# ARCHITECTURAL REVIEW BOARD APPLICATION

## INCORPORATED VILLAGE OF EAST HILLS ARCHITECTURAL REVIEW BOARD

Re: Mehta Residence (133 Round Hill Road, East Hills, NY, 11548)  
Section 7 Block 140 Lot 120

Please find attached two copies(2) of updated large format drawings based on the comments of the previous Architecture Review Board hearing. The changes are as follows

# LANDSCAPE PLOT PLAN

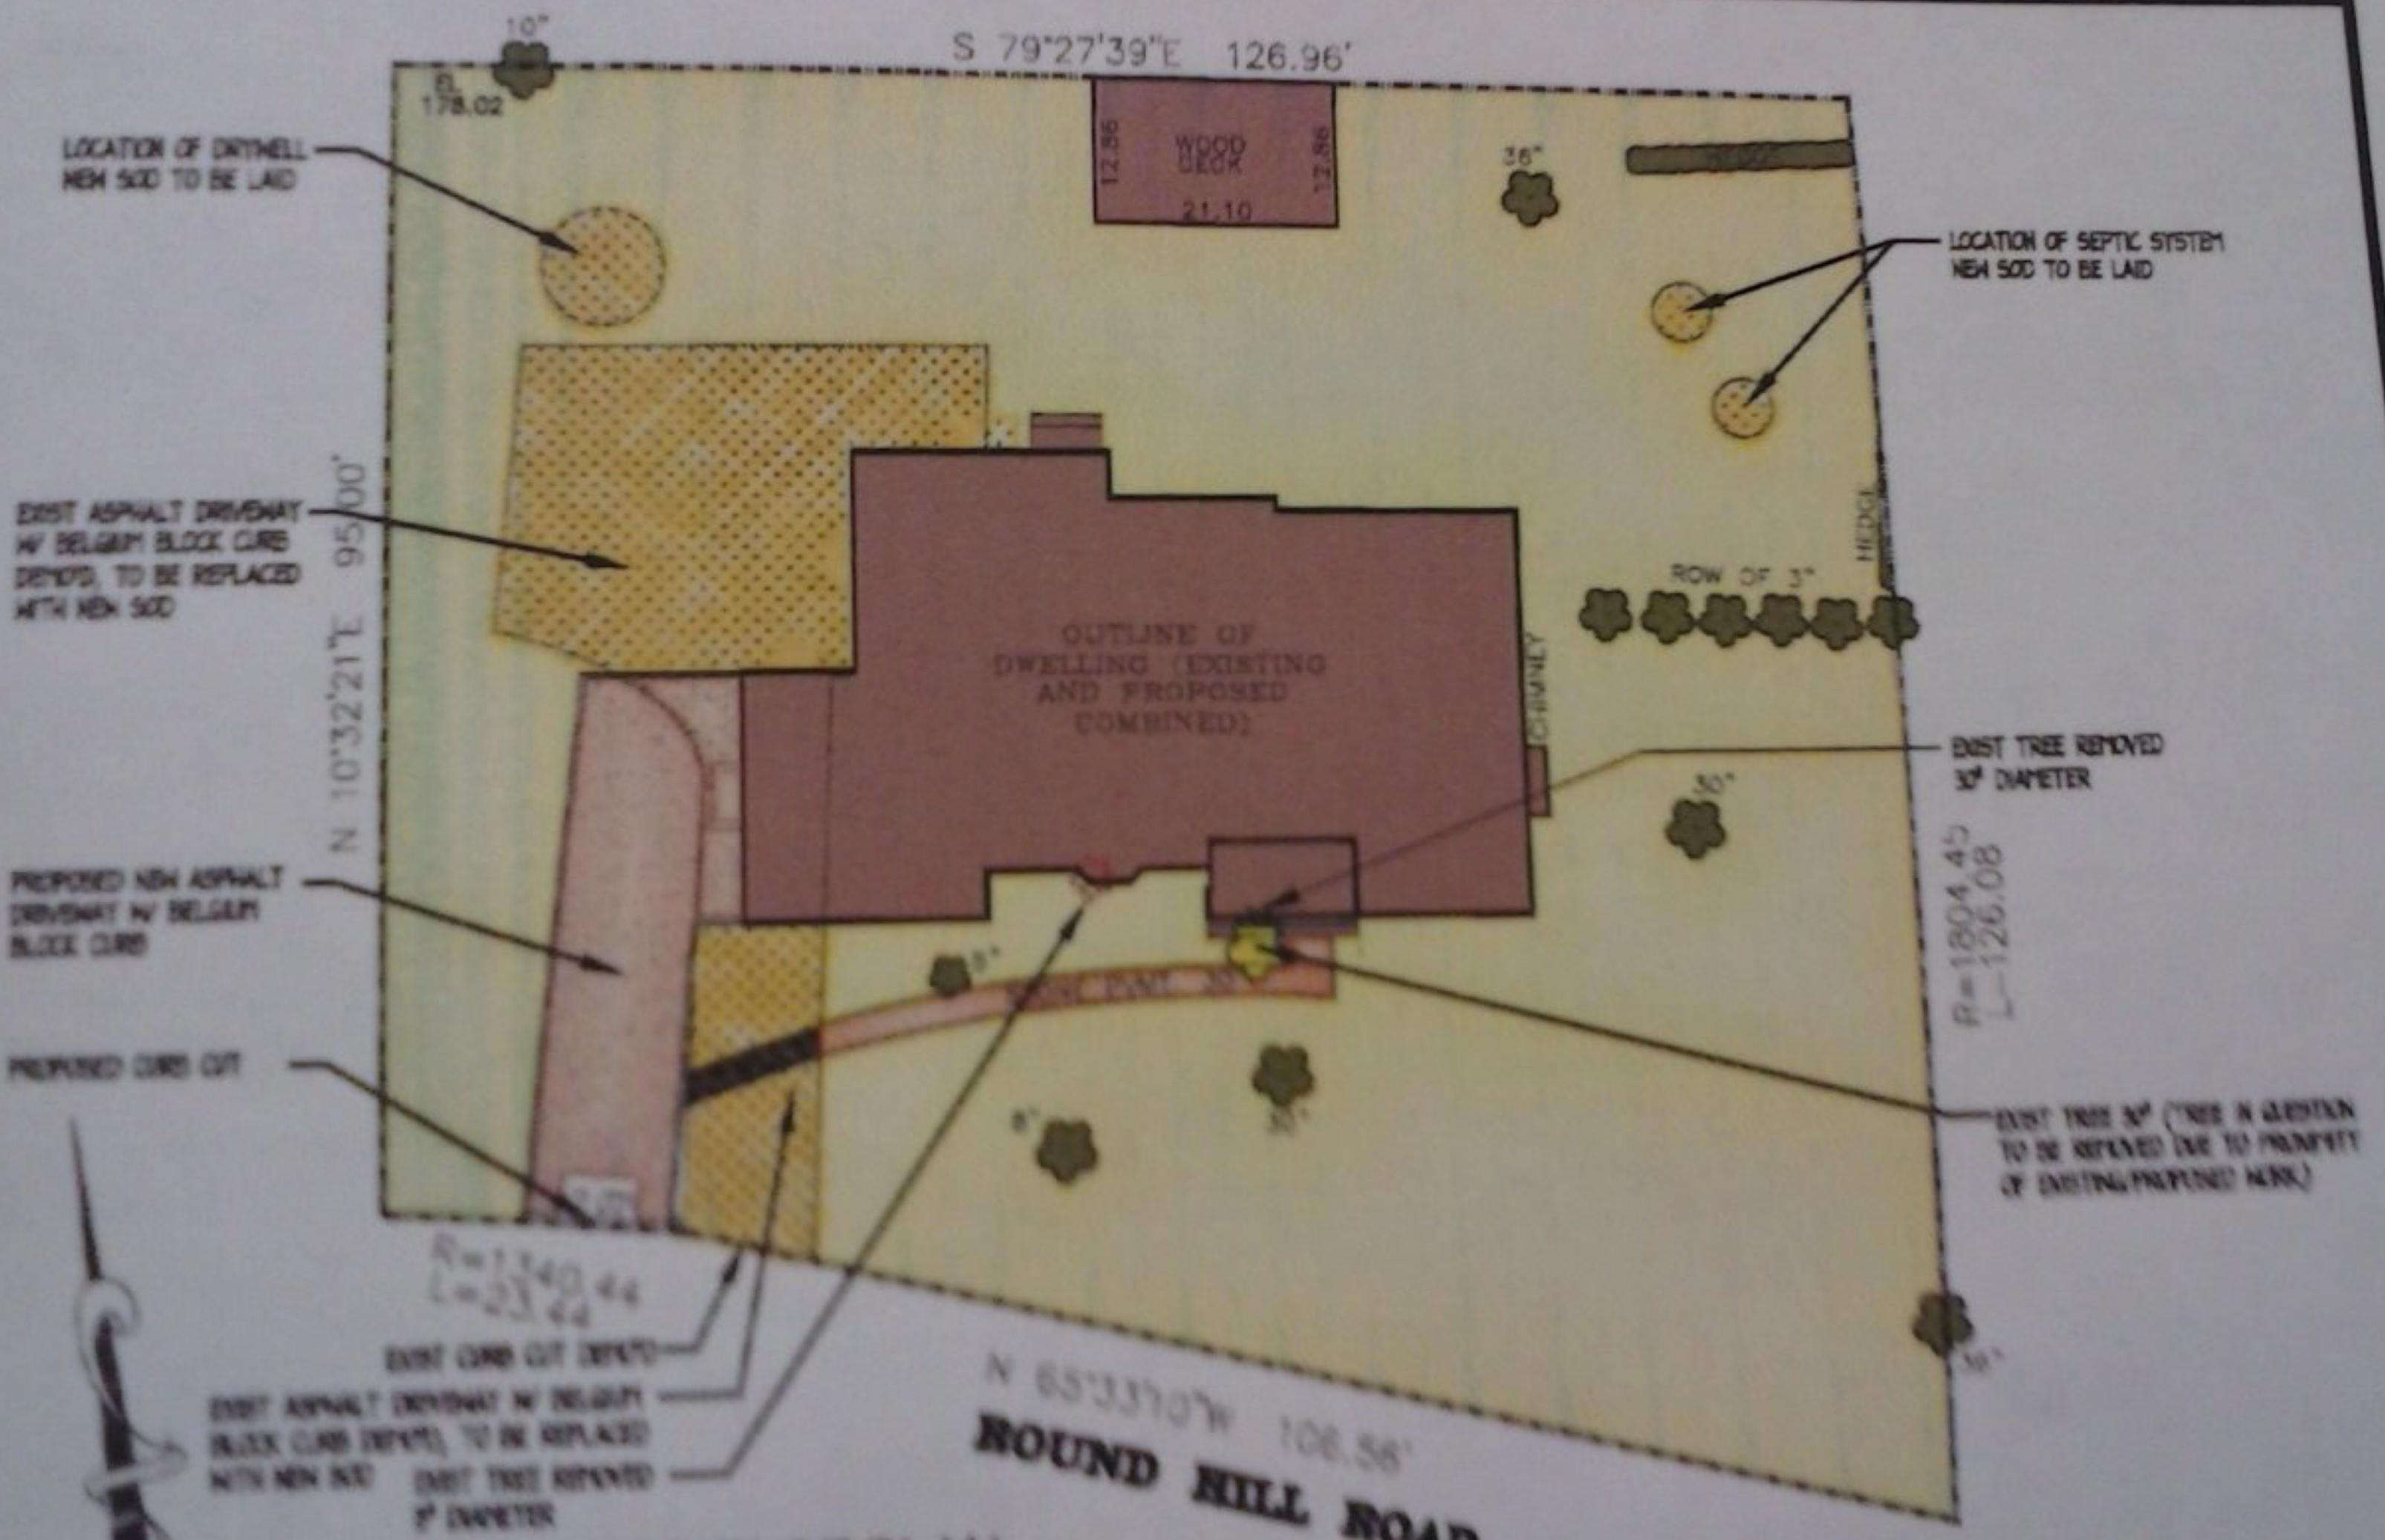
Reason for Removal:

DECIDUOUS

30"

PROXIMITY TO DWELLING / SAFETY

PINE

8"

2<sup>ND</sup> ADDITION

CONSTRUCTION DOCUMENTS  
LANDSCAPE PLAN

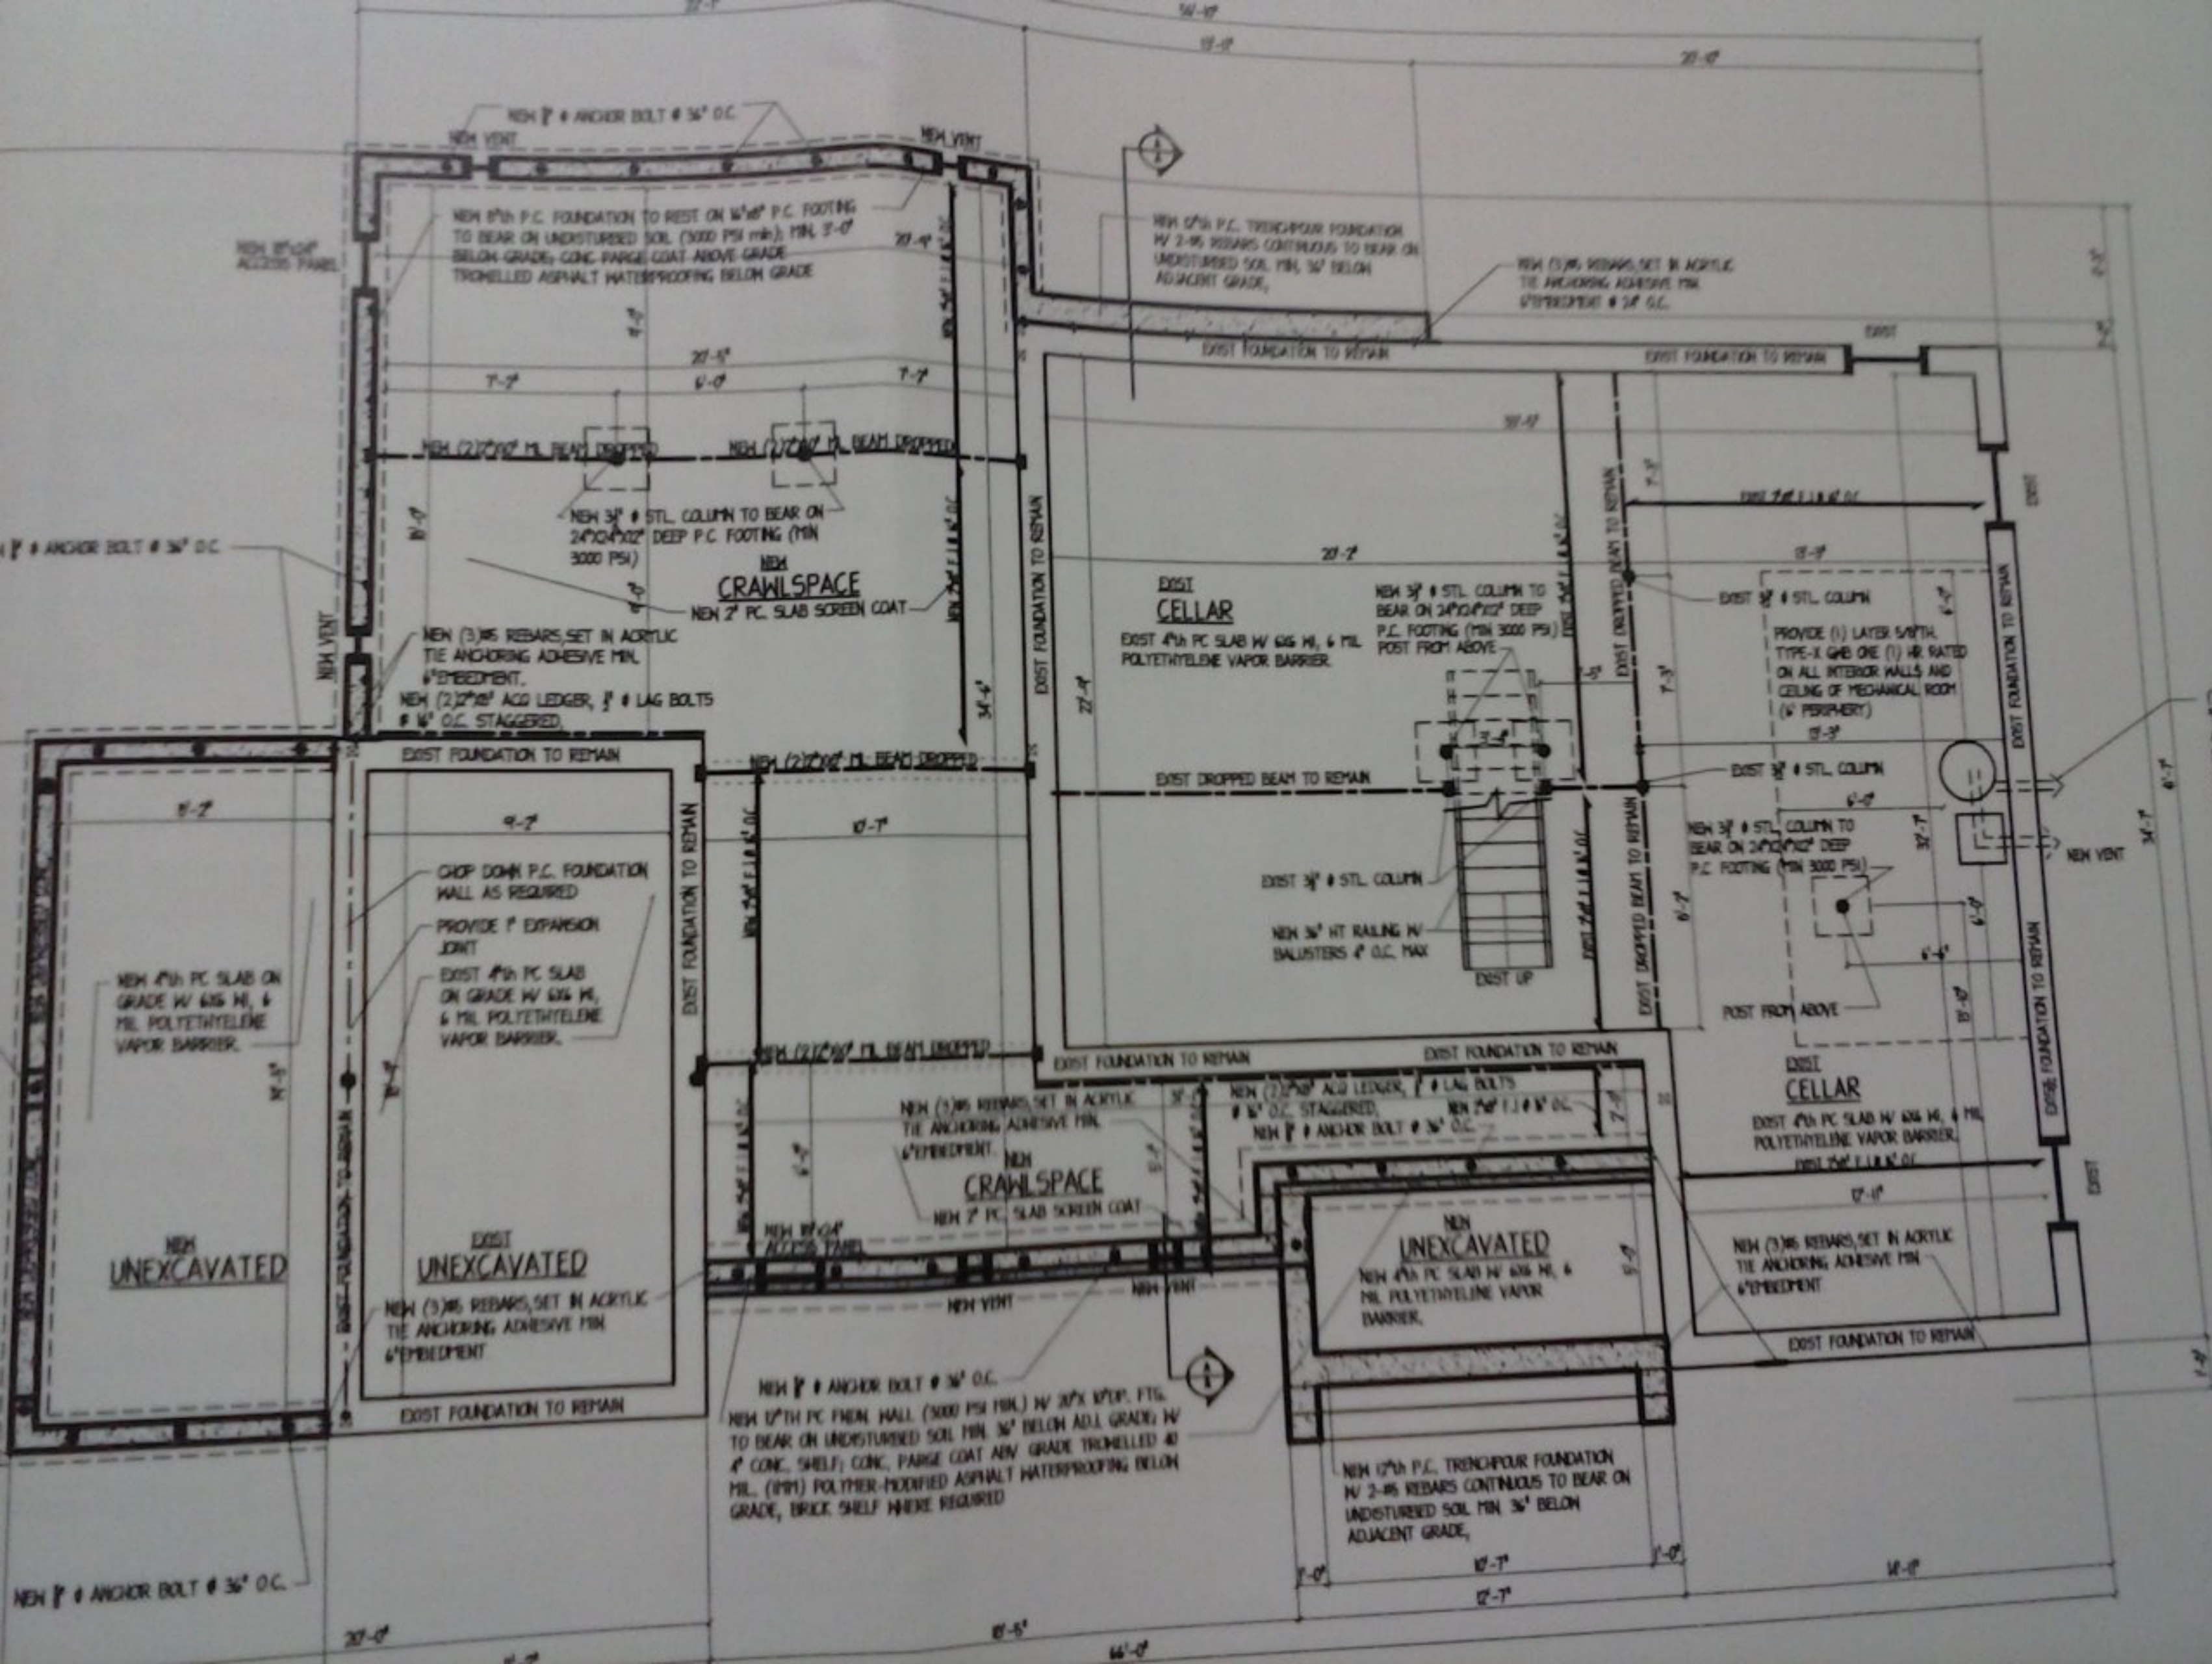
As per direction from the Village of East Hills Architectural Review Board a reduction of 50% of the initially proposed tree removal is agreed upon and reflected in the latest plans. However the salvage of one of the trees originally included in the removal still poses an issue, as stated below:

One tree, a 30" diameter mature tree, which is no longer within the footprint of the new construction, is within ten feet of the existing dwelling and within a foot of the proposed construction (see construction documents, landscape plan). This tree can be viewed as a potential hazard for the homeowners and their family. It also becomes a challenge to save the tree with the construction happening in such close proximity to the dwelling.

The tree canopy currently overhangs approximately 60% over the current dwelling with many potential "widow makers" branches above the roof and pathway. In addition, the root ball which is normally two to three times the size of the canopy, will be interfered with when the new construction occurs. This will weaken the stability of the tree and could possibly kill it by removing such a large amount of its root system. If the tree does remain, not only will the root system need to be cut back but the canopy will need to be reduced as well. A full second story and roof structure would intersect with the lower areas of the canopy removing significant amounts of foliage. As stated, much of the tree's canopy overhangs the existing dwelling. Once all this work is done to salvage the tree, there will be littler remaining that the tree will have to survive on.

It is the opinion of our office that this tree will need to be removed even if it is not within the scope of the work. This tree will need to be removed for the safety of the owners, their children and the crew who is performing the work at the site. While this trees removal is regrettable, 13 of 15 trees, many of which are mature, are being saved.
